BODY/CHASSIS

3rd Row Seat Folding Actuator Lower Level Assembly

17MY-Onwards Discovery

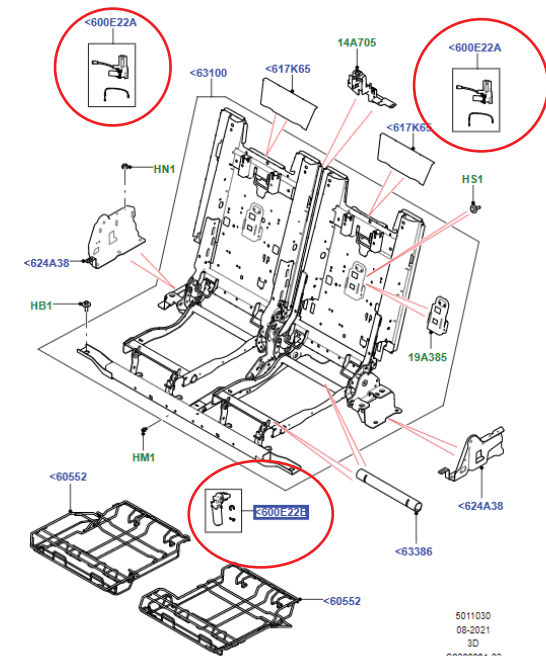
- A customer may report that the 3rd row seat backrest is stuck in the upright position.

- This may be caused by a 3rd row seat fold motor malfunction.

- The 3rd row seat backrest and base motors have now been released as a lower level service part, preventing the need to replace the seat frame assemblies to service the motors.
- Please refer to the lower level assembly service parts to conduct repairs wherever possible upon diagnosis of a seat fold motor failure.
- The service procedure has been added to the Workshop Manual, section 501-10: Seating > Removal and Installation > Third Row Seat Recline Motor or Third Row Seat Folding Actuator Motor.
